Access Compliance Report

Public Rights-of-Way

Intersection ID: 26115	Main Street: CARMEL_CHACE_DR	Cross Street: CARMEL_RD	Location: NE
ADA ID: 3BFF8896BE18	Ramp Type: PerpDiag	Initial Pass/Fail: Fail	Overall Compliance: No
Severity Score: 13.75			
Codes/Mitigation Info/Possible Solution		Field Measurements/Component Compliance

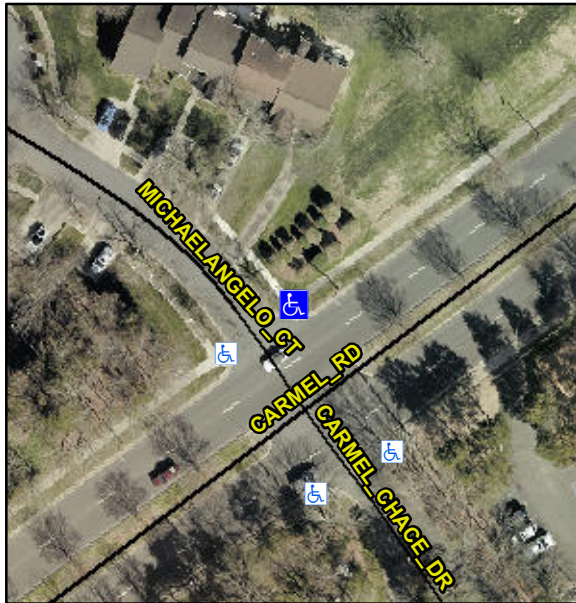
Remove & Replace Curb Ramp With Two New Directional Ramps or Equivalent.

R304.2.2, R304.5.3

Compliance	Description	Data	Compliance	Description	Data
N/A	Ramp Length (in)	96.0	No	Ramp Slope (%)	8.9
Yes	Ramp Width (in)	48.0	No	Ramp XSlope (%)	4.9
N/A	Flare Type LT	N/A	N/A	Flare Type RT	N/A
N/A	Flare Slope LT (%)	N/A	N/A	Flare Slope RT (%)	N/A
N/A	Flare Traversable LT?	N/A	N/A	Flare Traversable RT?	N/A
N/A	Landing Length (in)	N/A	N/A	DWS Provided?	N/A
N/A	Landing Width (in)	N/A	N/A	DWS Contrast?	N/A
N/A	Landing Slope (%)	N/A	N/A	DWS Length (in)	N/A
N/A	Landing X Slope (%)	N/A	N/A	DWS Full Width?	N/A
N/A	Landing Curb? (Y/N)	N/A	N/A	DWS Offset (in)	N/A
N/A	Shared Landing?	N/A			
N/A	Gutter Ponding?	N/A	N/A	Gutter Slope (%)	N/A
N/A	Gutter Lip Ht (in)	N/A	N/A	Gutter X Slope (%)	N/A
N/A	Painted X Walk1?	No	N/A	Painted X Walk2?	No
	X Walk 1 Direction	To W		X Walk 2 Direction	To S
N/A	X Walk 1 Width (in)	N/A	N/A	X Walk 2 Width (in)	N/A
	X Walk 1 Slope (%)	2.2		X Walk 2 Slope (%)	3.8
	X Walk 1 X Slope (%)	1.7		X Walk 2 X Slope (%)	3.1
